# CITY OF ALBUQUERQUE

Hydrology Section Planning Department  
David S. Campbell, Director

**RE: BEK Distribution Facility – 601 Gallatin Pl. NW  
G&D Plan and Drainage Report Engineers Stamp Date: 5/16/2019,  
Hydrology File: FJ10D002G1**

STORM SEWER  
PLAN AND PROFILE

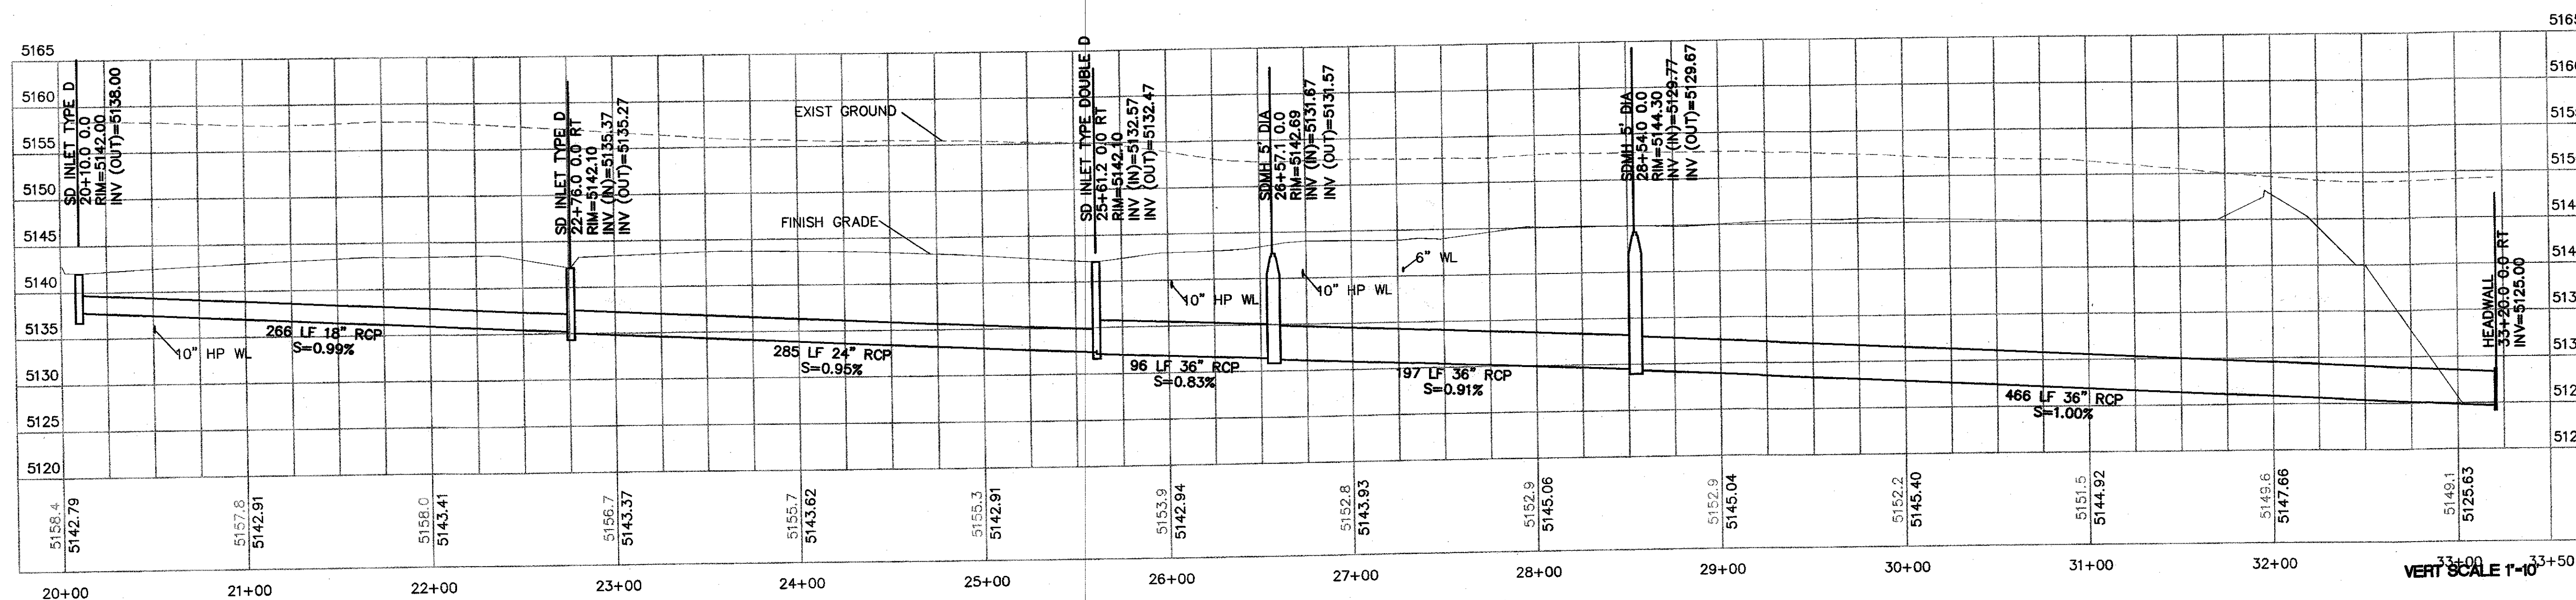
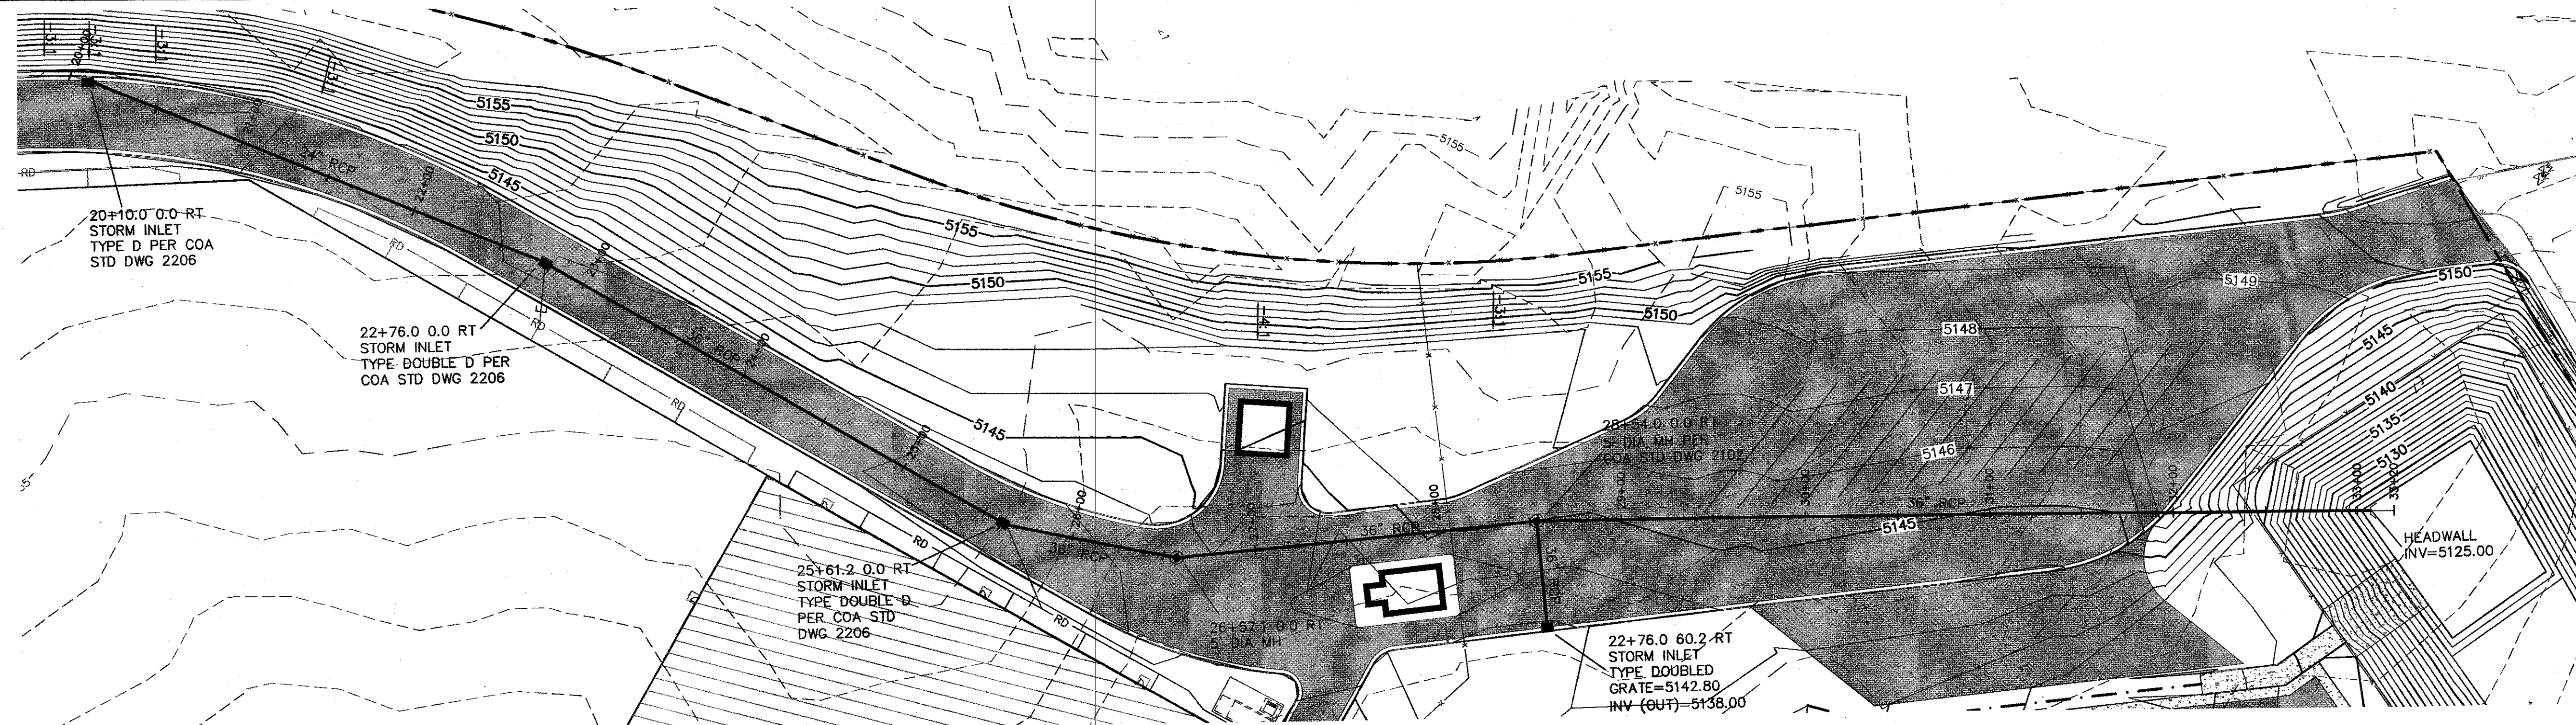
15. HGL calculations are required for the storm drain in the north east corner of the site where failure of the storm drain could result in excessive stormwater runoff to public streets. Also please add a profile and HGL calculations for the storm drain on the south and east side of the building.
